ACCESSIBILITY ASSESSMENT

February 4, 2025

ADA TITLE II ASSESSMENT

Agnes Stewart Middle School

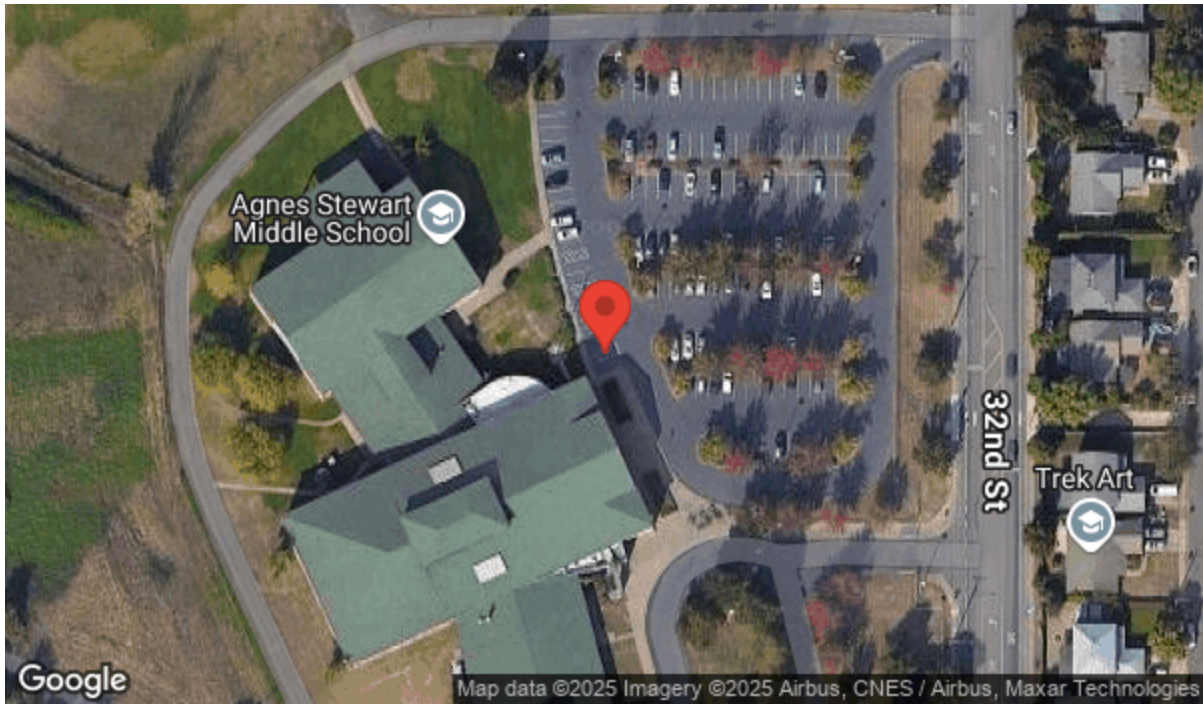
Assembly	Accessible Parking
Type	Parking Space - General
ADA Standard	502.4
Barrier Detail	The access aisle slope is greater than 1:50 (2%).
Location Description	Accessible Parking P1-A/B
Observed	Jan 15, 2025 by Thomas.chiarella@bureauveritas.com
Site Conditions	The cross slope of the access aisle is 2.3%.

Remove and replace with an adjacent access aisle that has a slope of maximum 1:50 (2%) in all directions. [EXCEPTION: Slopes not steeper than 1:48 (2.08%) shall be permitted.] Changes in level are not permitted. Parking spaces and access aisles serving them shall be compliant. Access aisles shall be at the same level as the parking spaces they serve. Measurements shall be made to the centerline of the stripe. Where accessible stalls and aisles are not adjacent to another stall or aisle, measurements shall be permitted to include the full width of the line defining the accessible parking space or aisle. The quantity and order of magnitude cost estimate provided for this barrier are limited to the extent of the area identified as non-compliant. Additional costs that may be associated with removal of the barrier are not included.

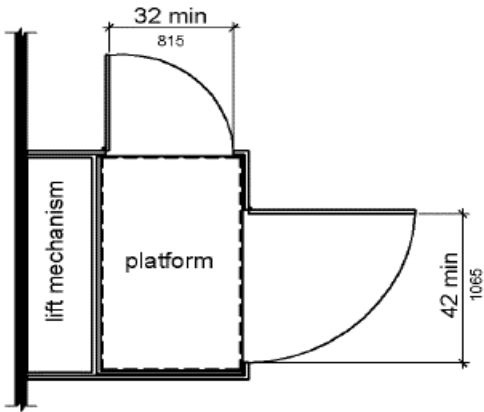
Assembly	Interior Access Route
Type	Platform Lift
ADA Standard	206.7, 207.2, 410;302; 303; 309; 404.3, 410.1
Barrier Detail	A platform lift is required but not provided.
Location Description	Cafeteria
Observed	Jan 15, 2025 by Thomas.chiarella@bureauveritas.com

Compliant vertical access to the stage is not provided. Access to the stage is by stair only.

Install a platform lift. Platform lifts shall not be attendant-operated and shall provide unassisted entry and exit from the lift. Floor surfaces in platform lifts shall be firm, stable and slip resistant. Clear floor space in platform lifts shall be minimum 30" by minimum 48". Controls for platform lifts shall be within allowable reach ranges, and shall be operable without tight grasping, pinching, or twisting of the wrist. The force required to operate the controls shall not be greater than 5 lbs of force. Platform lifts shall have low-energy power-operated doors or gates. Doors shall remain open for 20 seconds minimum. End doors and gates shall provide a clear width 32" minimum. Side doors and gates shall provide a clear width 42" minimum. [EXCEPTION: Platform lifts serving two landings maximum and having doors or gates on opposite sides shall be permitted to have self-closing manual doors or gates.] If platforms are used, they shall conform with the applicable safety regulations of administrative authorizes having jurisdiction. Platform lifts shall comply with ASME A18.1 (1999 edition or 2003 edition). Platform lifts shall be permitted as a component of an accessible route in an existing building. Platform lifts can be part of the accessible means of egress where standby power is provided, and in the following situations: 1. An accessible route to a performing area and speakers' platforms in occupancies in Group A; 2. An accessible route to wheelchair spaces required to comply with the wheelchair space dispersion requirements; 3. An accessible route to spaces that are not open to the general public with an occupant load of not more than five; 4. An accessible route within a dwelling or sleeping unit; 5. An accessible route to wheelchair seating spaces located in outdoor dining terraces in A-5 occupancies where the means of egress from the dining terraces to a public way are open to the outdoors. 6. An accessible route to raised judges' benches, clerks' stations, jury boxes, witness stands and other raised or depressed areas in a court; 7. An accessible route where existing exterior site constraints make use of a ramp or elevator infeasible.

Photos for Barrier ID: AX556881

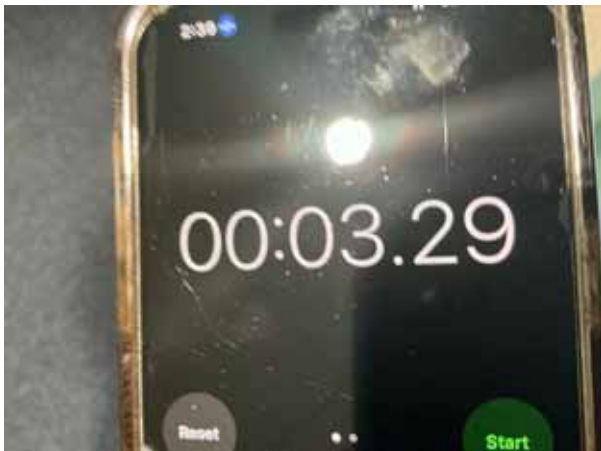
Assembly	Entrance to Building	
Type	Building Entrance - Door	
ADA Standard	404.2.9	
Barrier Detail		
The opening force of the fire door is more than the minimum allowable by the appropriate administrative authority.		
Location Description	Door D-2 Office	
Observed	Jan 15, 2025 by Thomas.chiarella@bureauveritas.com	
Site Conditions	The opening force of the fire door is 14 pounds.	
Resolution		
Adjust the closer/opener or replace with a door which requires no more force to open and close than the minimum allowable force required by the appropriate administrative authority. The force at the latch, the force to set the door in motion, and the force to fully open the door shall be the minimum allowable. These forces do not apply to the force required to retract latch bolts or disengage other devices that hold the door or gate in a closed position.		
Quantity	Unit Cost	Total Cost
1 EA	457.50	\$ 458
Priority	1

Photos for Barrier ID: AX556879

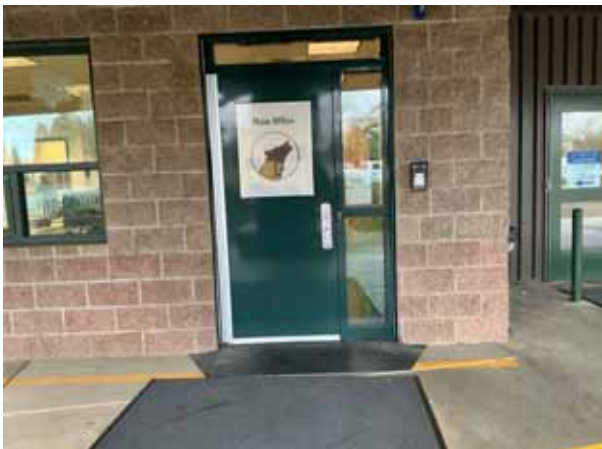
Assembly	Entrance to Building	
Type	Building Entrance - Door	
ADA Standard	404.2.9	
Barrier Detail		
The opening force of the fire door is more than the minimum allowable by the appropriate administrative authority.		
Location Description	Door D-3 Gym	
Observed	Jan 15, 2025 by Thomas.chiarella@bureauveritas.com	
Site Conditions	The opening force of the fire doors is 16 to 18 pounds.	
Resolution		
Adjust the closer/opener or replace with a door which requires no more force to open and close than the minimum allowable force required by the appropriate administrative authority. The force at the latch, the force to set the door in motion, and the force to fully open the door shall be the minimum allowable. These forces do not apply to the force required to retract latch bolts or disengage other devices that hold the door or gate in a closed position.		
Quantity	Unit Cost	Total Cost
4 EA	457.50	\$ 1,830
Priority	1

Photos for Barrier ID: AX556908

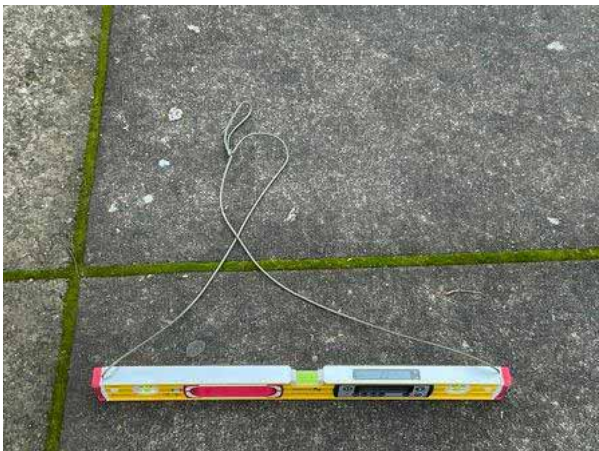
Assembly	Exterior Access Route	
Type	Exterior Accessible Route	
ADA Standard	403.3	
Barrier Detail		
The accessible route has greater than 1:20 (5%) running slope and 1:50 (2%) cross slope.		
Location Description	From Site Entrance to Street	
Observed	Jan 15, 2025 by Thomas.chiarella@bureauveritas.com	
Site Conditions		
The exterior accessible route has cross slopes of 2.2%. The non-compliant portion of the walk is 8' wide, 24' in length.		
Highest Cross Slope	2.2%	
Length	24'	
Width	8'	
Resolution		
The accessible route should be graded to a maximum 1:20 (5%) running slope and 1:50 (2%) cross slope. An accessible route has maximum 1:20 (5%) running slope, maximum 1:50 (2%) cross slope. [EXCEPTION: Cross slopes not greater than 1:48 (2.08%) are permitted.] Where grading to maximum running slope of 1:20 (5% running slope) is not possible, provide a compliant ramped surface within the walkway with maximum slope 1:12 (8.33%) and maximum ramp run rise of 6" without handrails. If a ramped surface with running slopes greater than 1:20 (5%) and maximum 1:12 (8.33%) rises more than 6", handrails are required. An accessible route has a minimum clear width 36". [EXCEPTION: The clear width shall be permitted to be reduced to 32" minimum for a length of 24" maximum provided that reduced width segments are separated by segments that are 48" long minimum and 36" wide minimum.] The cost estimate for this barrier removal is based on grading the running slope to maximum 1:20 (5%). The quantity and order of magnitude cost estimate provided for this barrier are limited to the extent of the area identified as non-compliant. Additional costs that may be associated with removal of the barrier are not included.

Photos for Barrier ID: AX558097

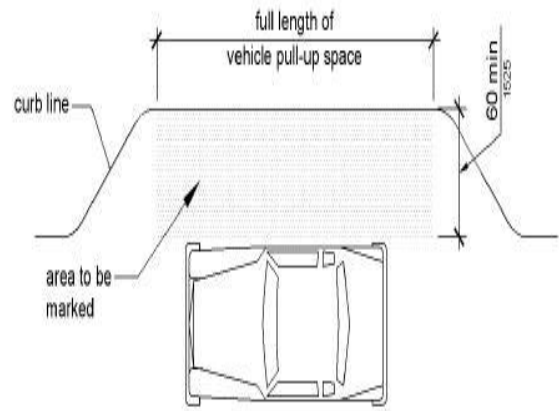
Assembly	Exterior Access Route
Type	Curb Ramp
ADA Standard	406.2
Barrier Detail	A curb ramp is not provided where the accessible route crosses a curb.
Location Description	Loading/Unloading Zone
Observed	Jan 15, 2025 by Thomas.chiarella@bureauveritas.com
